**Site Location:** 84-160 Christensen Road South, STAPYLTON

**Reference No:** MCU/2022/291

**Subject:** Response to Information Request – Traffic Matters

### Amended Architectural Plan / Swept Path

**Figure 1 – Fence**

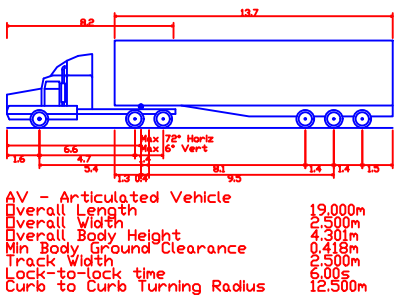
- a. Provide pedestrian sight triangles on both sides of both driveways in accordance with the requirements of section 3.4.5(b) of AS2890.2:2018. Relocate the security gates and any other obstruction a minimum of 2.5m into the site clear of the pedestrian sight triangles. Also, include the following annotation to clearly indicate the intent being that the “Pedestrian sight triangle to be kept clear of obstructions to visibility. Low level landscaping permitted to a maximum mature height of 500mm above driveway level”.*
- b. Relocate the proposed ‘container zone’ elsewhere onsite where it will not impact access and manoeuvring of heavy vehicles. Before responding to this point, the applicant is requested to discuss the alternate location with Transport Assessment.*

In relation to item 7a, pedestrian sight triangles have been shown on the amended plan. The purpose of these sight triangles is to ensure that motorists leaving the sight have a clear line of sight to pedestrians within the verge. It is for that reason that low landscaping (i.e below 500mm) is permitted within these areas. As noted in our response to item 6, the front fence and gate will be made of slim tubular vertical elements, similar to a pool fence. Just like a pool fence which is purpose built to allow visibility into a pool area, the fence will not impede the visibility between a motorist and a pedestrian within the verge. As a consequence, the fence and gate can be constructed on the front boundary.

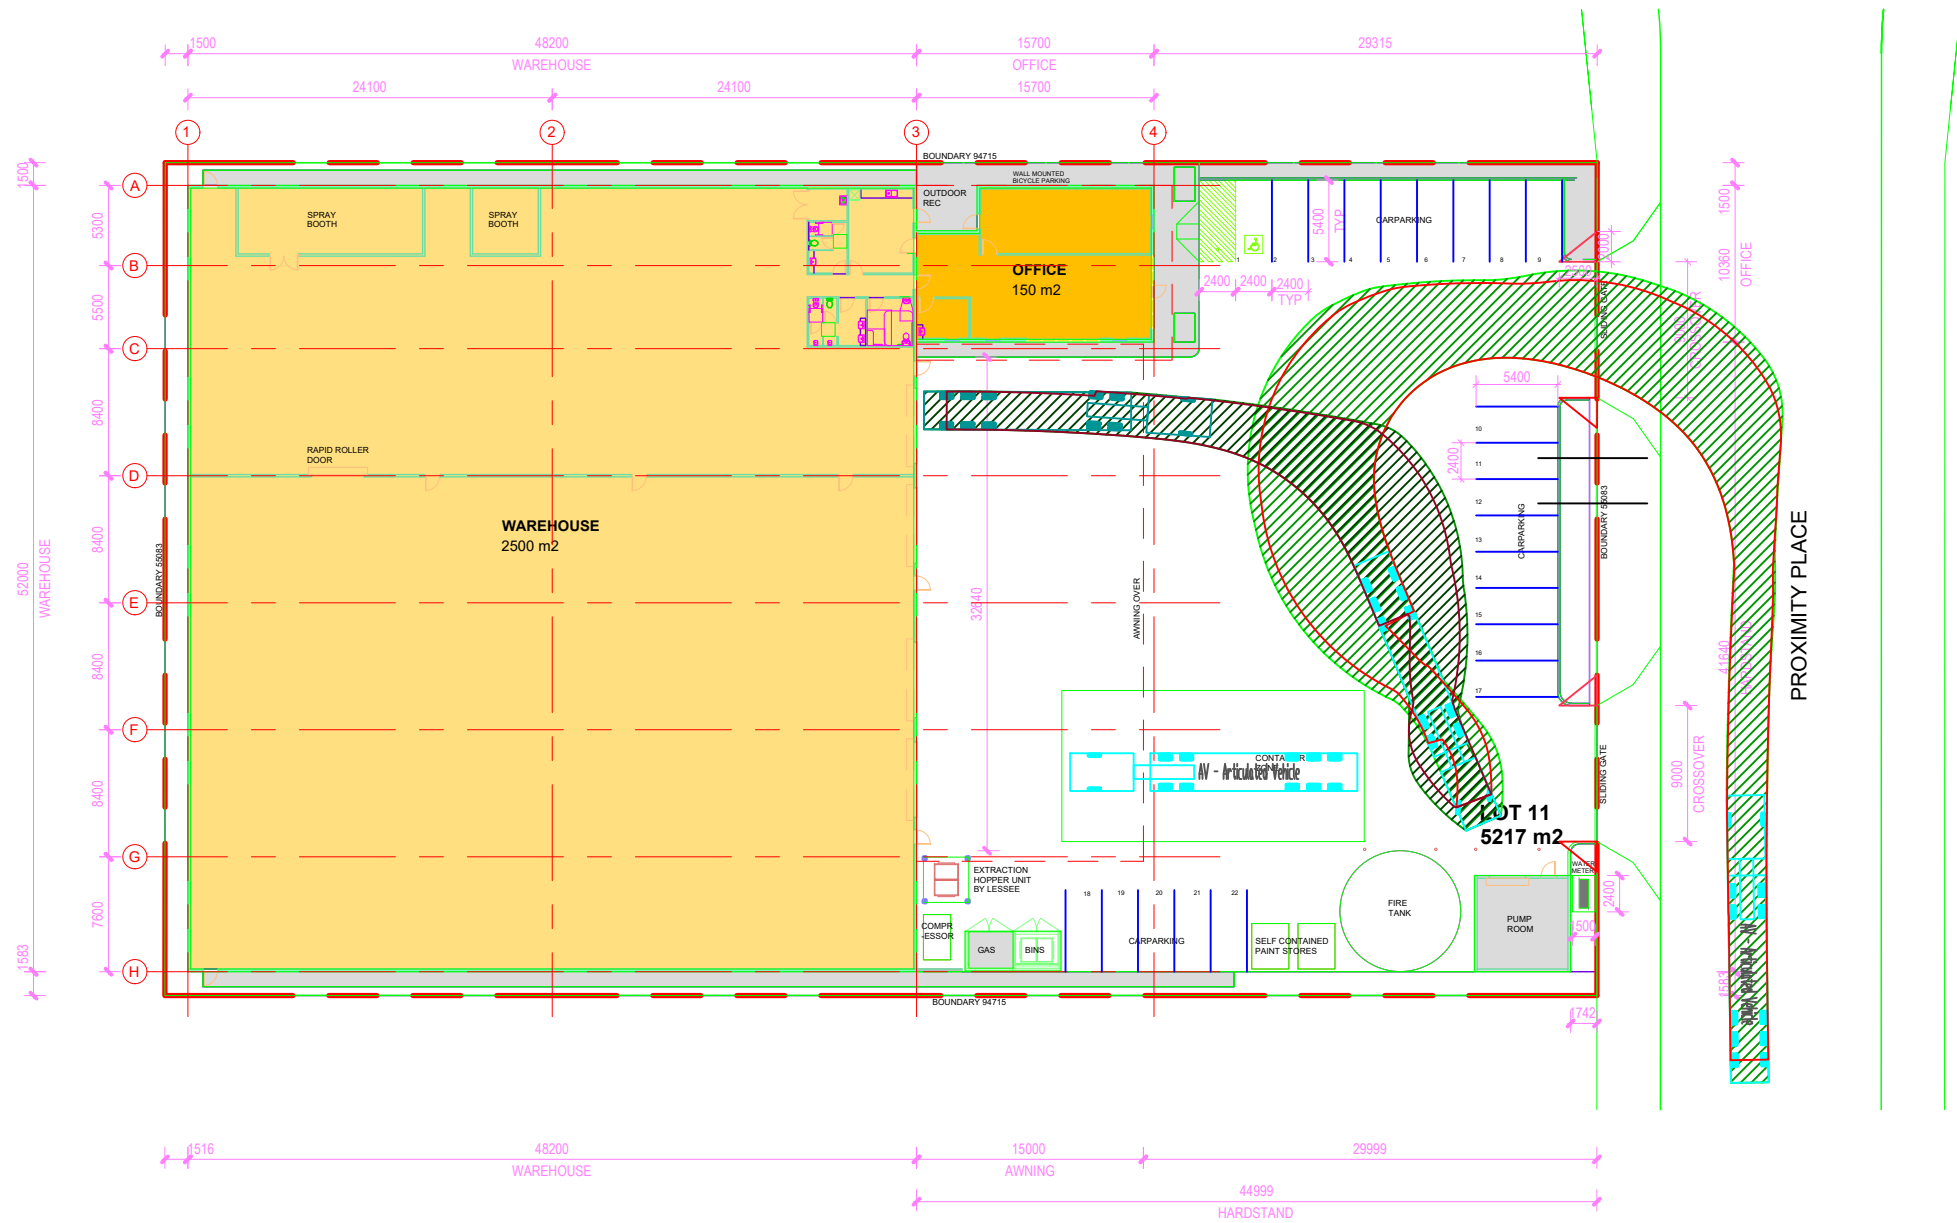
*To comply with Acceptable outcome AO1 of the Driveways and vehicular crossings code, the vehicular crossings must be designed in accordance with the City's Land Development Guidelines, specifically IPWEAQ Standard Drawing RS-051 – Heavy Duty Vehicle Crossing. In this regard, while the northern vehicle crossing will mostly be used by light vehicle traffic, officers consider that it may also be used by heavy vehicles up to a 20m Articulated Vehicle (AV). The applicant is therefore requested to widen this vehicle crossing from 6m as proposed to 9m to match the southern vehicle crossing width. The PWD is to have a shared area in accordance with the Australian Standards (AS/NZS 2890.6-2009).*

*To comply with Acceptable outcome AO2 of the Transport code, the applicant is requested to submit an amended drawing showing a notation advising that the gate will be opened by the first staff member to arrive onsite each day and remain open for visitor access during the hours of operation. The gate and front fencing must be set into the site to account for widening and land dedication requirements associated with the proposed site access intersection.*

*To comply with Performance outcomes PO10 and PO12 of the Transport code, the applicant is requested to submit an amended drawing identifying a location where staff could store a bicycle internal to the tenancy should they decide to ride to work. Bicycle parking areas must be located as close as practical to the cyclist's ultimate destination, desirably somewhere near the office and amenities.*

*To comply with AO25.1 of the Transport code, the applicant is requested to submit amended drawings showing the following amendments:*

- a. Dimension all car parking facilities to show compliance with the requirements of AS2890.1:2004.*
- b. Show the access driveway and main car parking area to be drained sealed and line marked.*

In As requested by Council, the plan has been amended to provide a 9.0m wide northern crossover. As Council have stated, this then provides flexibility for heavy vehicles to use this crossover as well as the southern crossover.

As requested by Council, the amended plan include a notation advising that the gate will be opened by the first staff member to arrive onsite each day and remain open for visitor access during the hours of operation. With respect to the gate and front fencing, this is located on the front property alignment and given the gate consists of slim tubular vertical elements (i.e similar to a pool fence), they do not impede visibility between vehicles exiting the property and pedestrians within the verge.

In relation to item 7b, the container zone is simply area of reinforced concrete that could be used to unload a container. This is infrequent. The site will typically be serviced by MRV and HRV's. On occasion a large container may be delivered to the site and would unload in the area shown. The northern crossover which has been widened to 9.0m could be used to ensure that vehicles can continue to access the site even if a container is being unloaded. The swept paths are included as **Attachment 1**.

Wall mounted bicycle parking is shown on the plans adjacent to the office. Given the warehouse is 2,500m<sup>2</sup>, staff would also have the option to store the bicycle within the warehouse.

Refer to the amended plans included as **Attachment 1** which has been dimensioned.
